AP1000 DOCUMENT NO.	REVISION	PAGE	ASSIGNED TO	OPEN ITEMS (Y/N)
APP-GW-GLR-134	1	1 of 470	W-Sterdis

TITLE: **AP1000 DCD Impacts to Support COLA Standardization**

AP1000 Standard Combined License Technical Report

Figure 3.8.2-4 (Sheet 2 of 6)

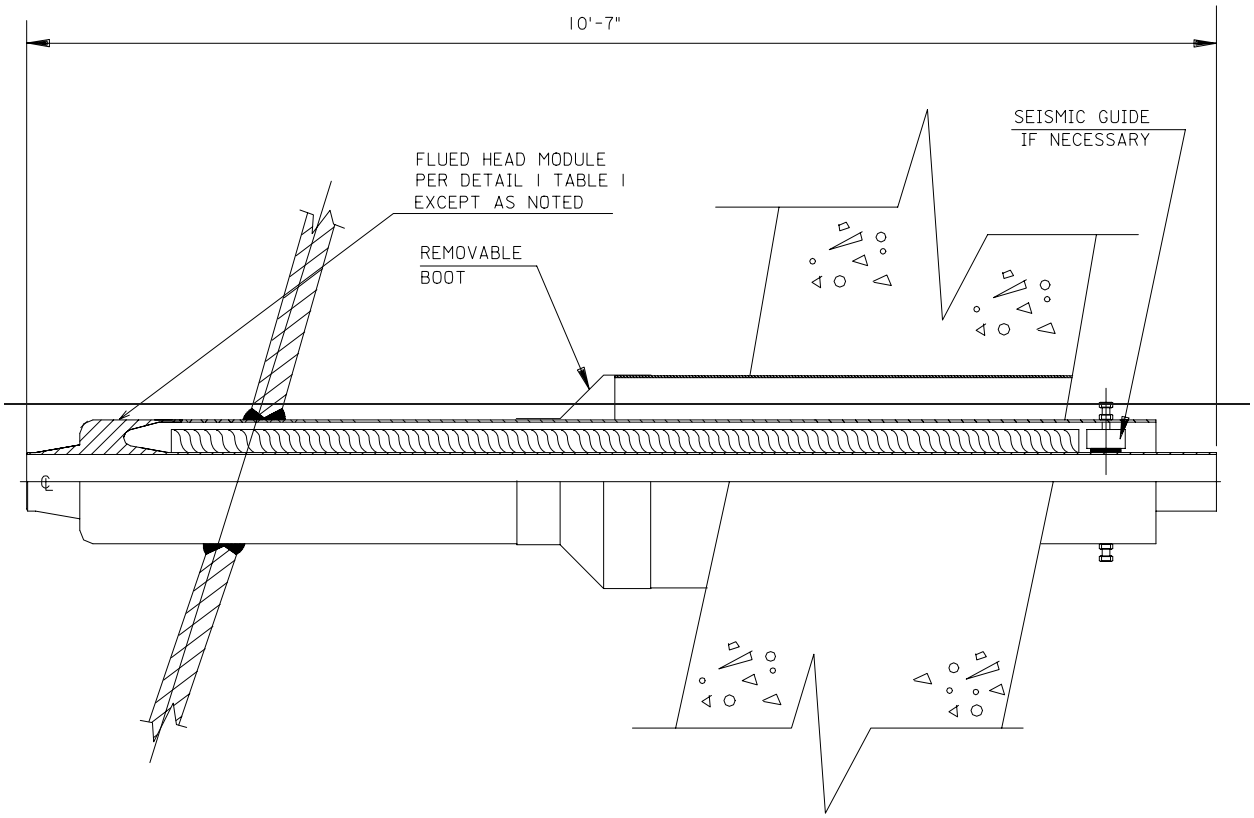
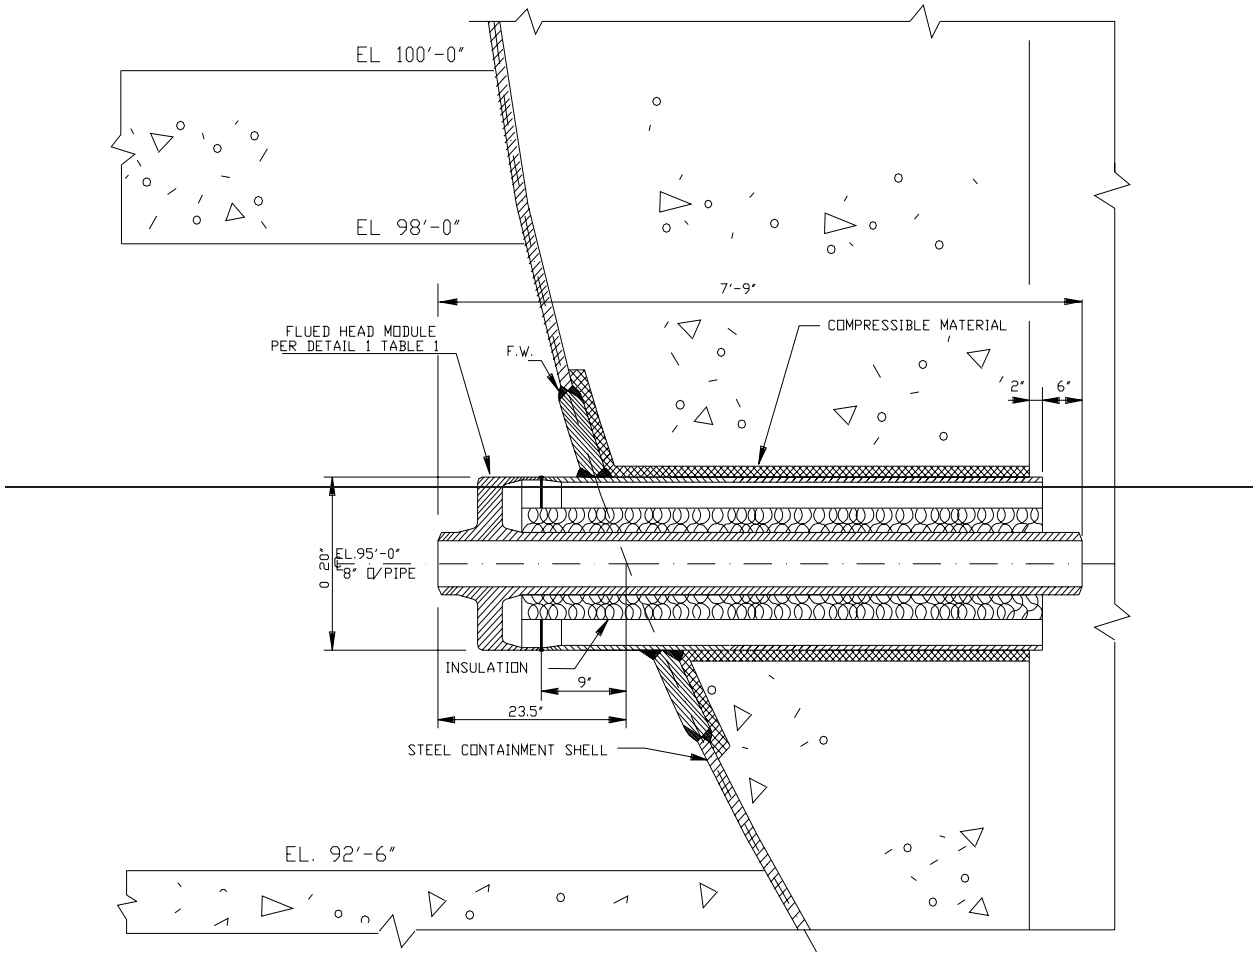
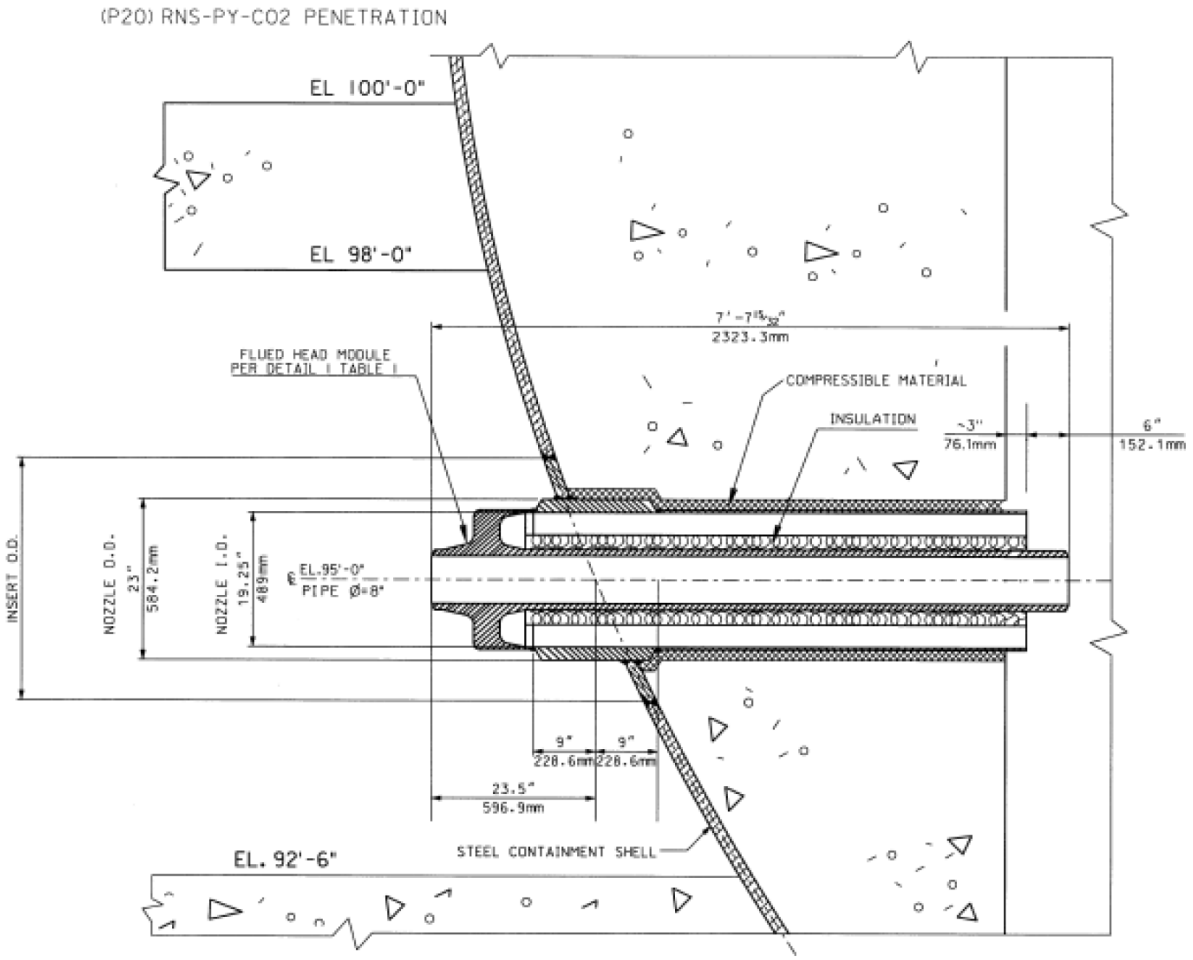
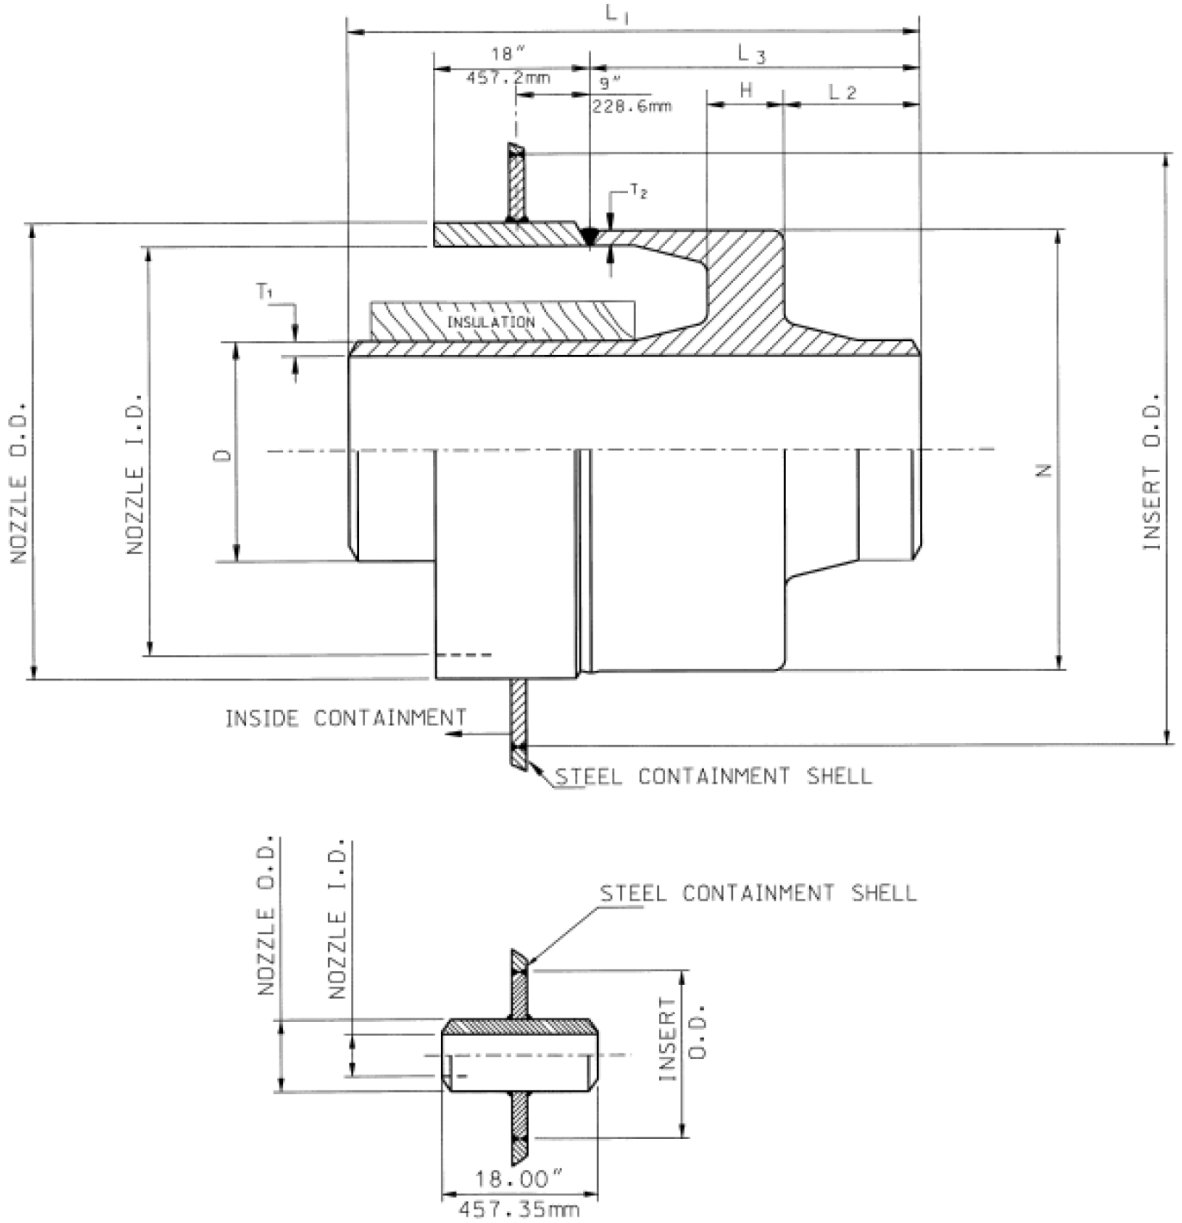
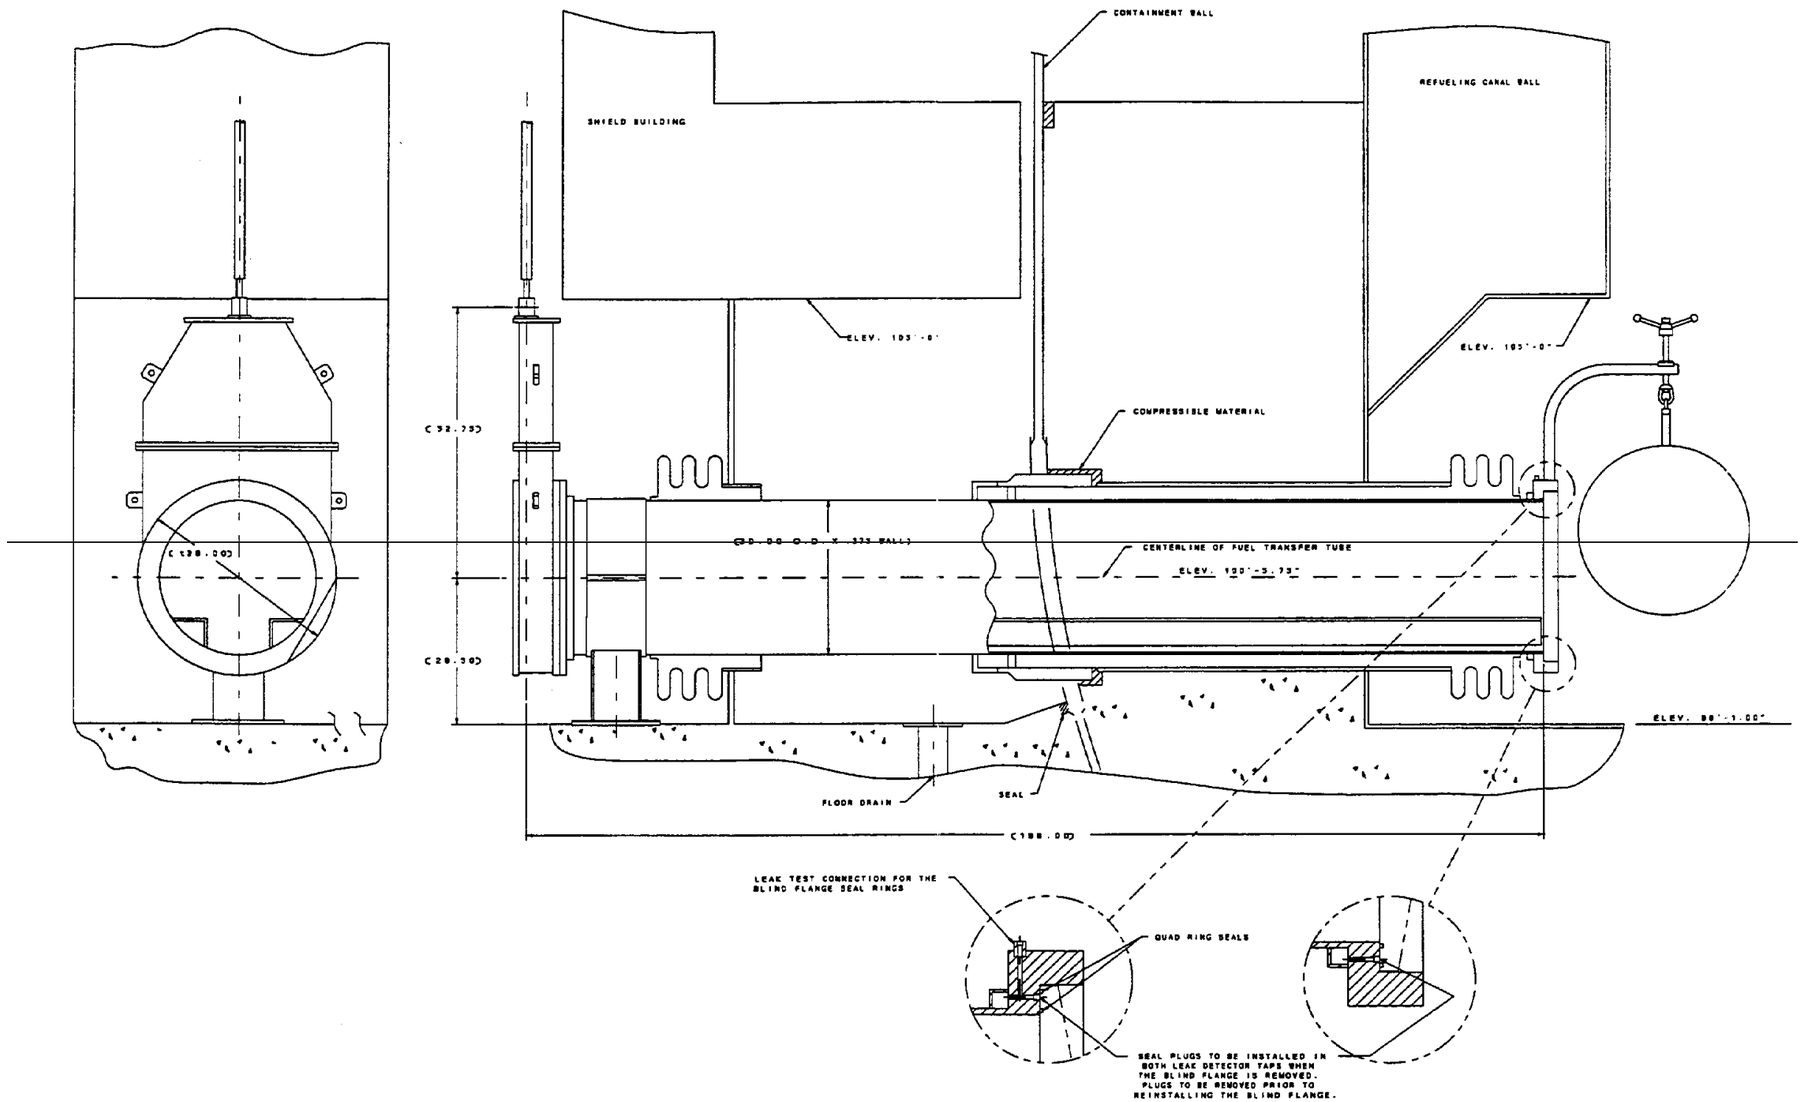
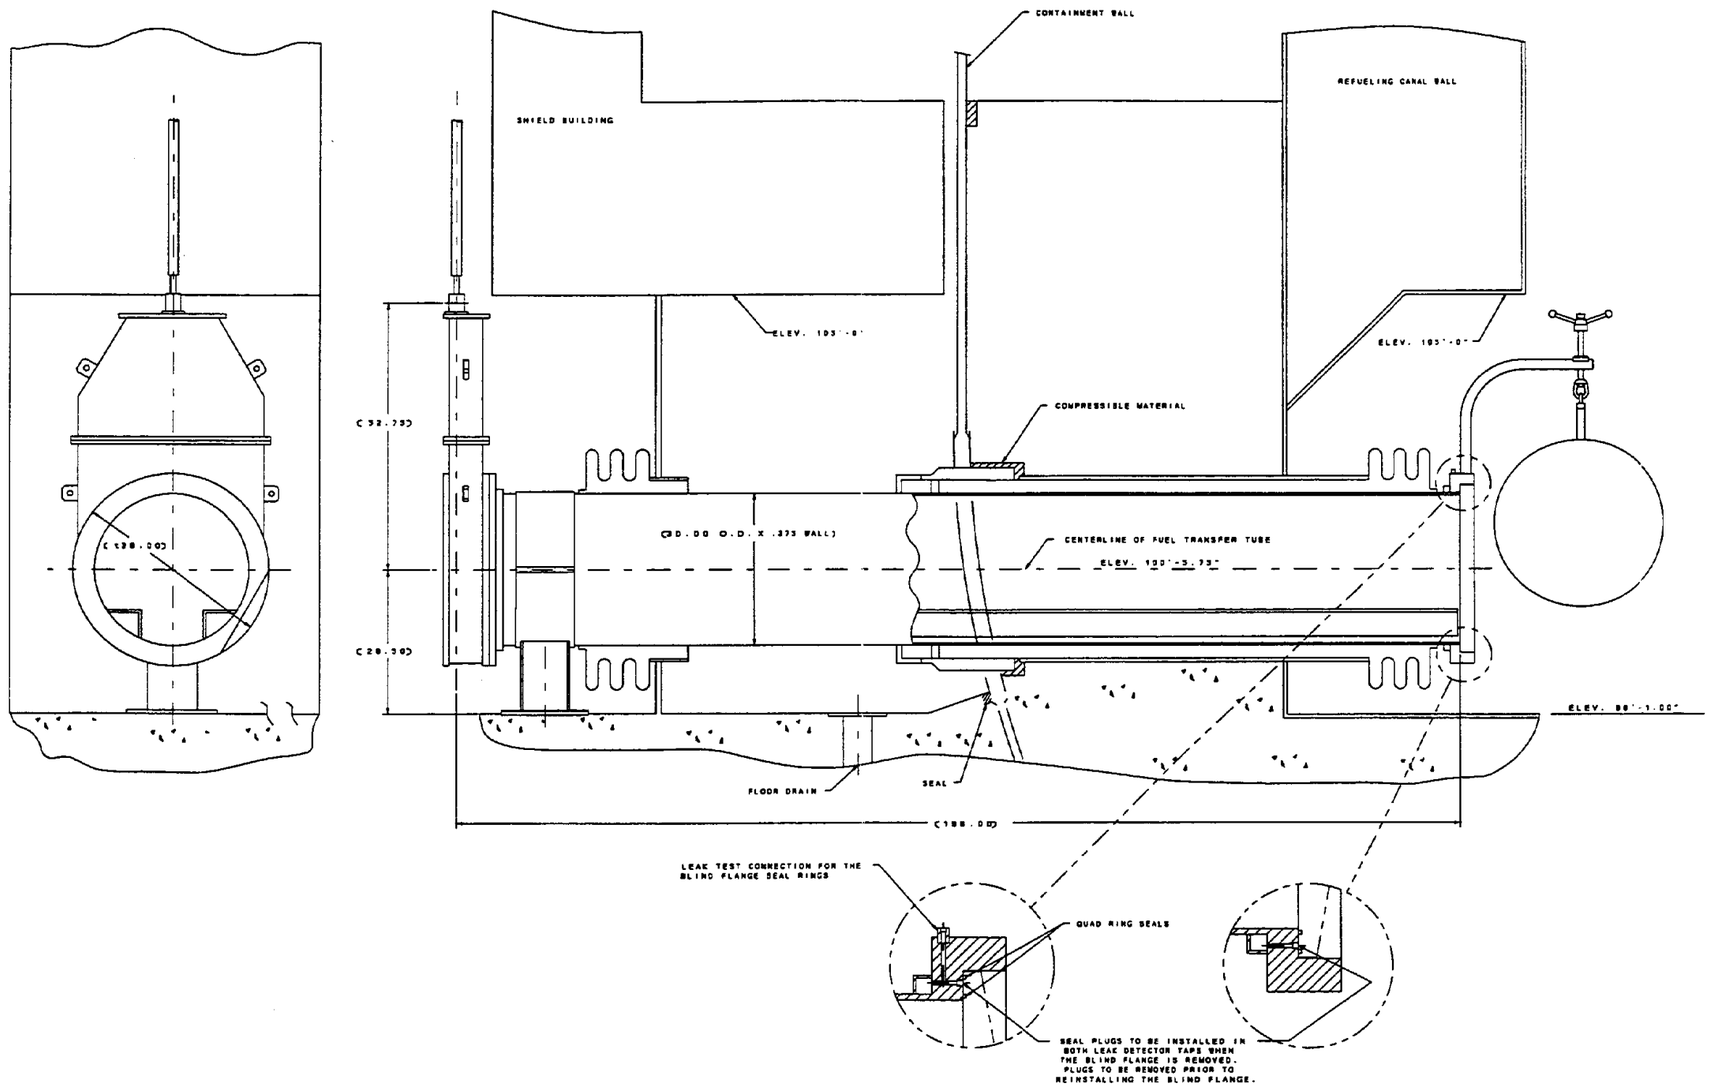
NRC044 contains corrections to Table 3.2-3, Figure 3.8.2-4 of DCD Revision 16. The basis for the change is RAI-TR09-003.
